Postcode: 200233 <u>LIU Jia</u> Shanghai Patent & Trademark Law Office, LLC No. 435 Gui Ping Road Shanghai City 200233 China	Date of Issue:  Patent Office (Sealed) 6 June 2008
Application No.: 2005100966408	
Applicant: CDX Gas, LLC	
Name of Invention: Method and system for accessing subterranean deposits from the surface

### Advice on 1st Assessment Comments

Application Number: 2005100966408

This application relates to a method and system for accessing subterranean deposits from the surface. After assessment, the following assessment opinions are presented.

图 1

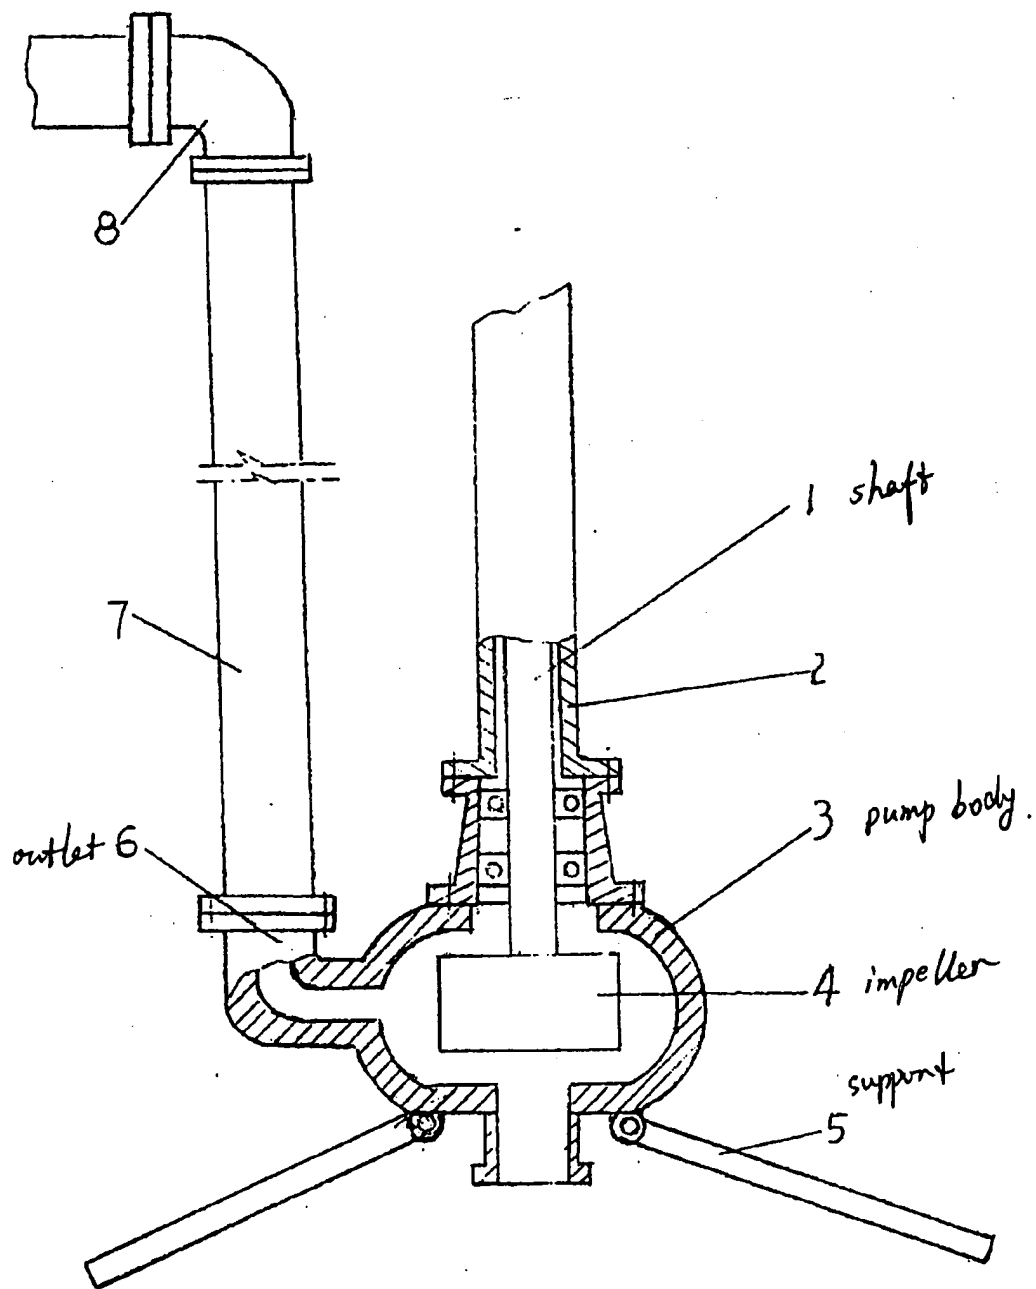
1. The technical scheme for which protection is claimed by Claim 1 does not possess novelty as stipulated under Clause 2 of Article 22 of the Patents Act. The comparison document 1 (CN2248254Y) discloses a soft-shaft deep well water pump, and in particular, a soft-shaft deep well water pump having the following characteristics: "A soft-shaft deep well water pump, wherein the pump body has an inlet portion (i.e. well bore portion) at its bottom that may extract fluid from the well, and the pump body has a retractable support bracket under it for its mounting onto the well wall (cavity positioning device); and the retractable support bracket is extended from a first position in the well to a second position to have the inlet portion positioned at a predetermined position in the well" (refer to Claim 1 and pages 1 - 2 and Figure 1 of the Prospectus for details). ...

... Comparing the contents disclosed in the comparison document 1 and the technical scheme for which protection is claimed by Claim 1, there is only a slight difference in literal expression. Both schemes fall within the same technical field, solve the same technical problems and produce the same technical result of positioning water pump in well. Therefore, the technical scheme for which protection is claimed thereby does not possess novelty.

The Applicant is required to reply within the time period specified by this advice addressing one by one all queries raised in this advice and to revise the patent application documents based on the comments of this advice. In particular, the Applicant is required to revise independent claims and the relevant dependent claims based on the comparison document cited by this advice, and to discuss in its statement of opinions the reasons of the newly revised independent claims possessing novelty and creativeness relative to the techniques existing prior to the application dates mentioned in the comparison document cited by this advice and relative to the techniques existing prior to the application dates mentioned in the original prospectus. In addition, the prospectus must be adjustably revised based on the revised claims. Revision of the application documents by the Applicant must be in conformity with the provision of Article 33 of the Patents Act and must not go beyond the scope of recording of the original prospectus and claims.
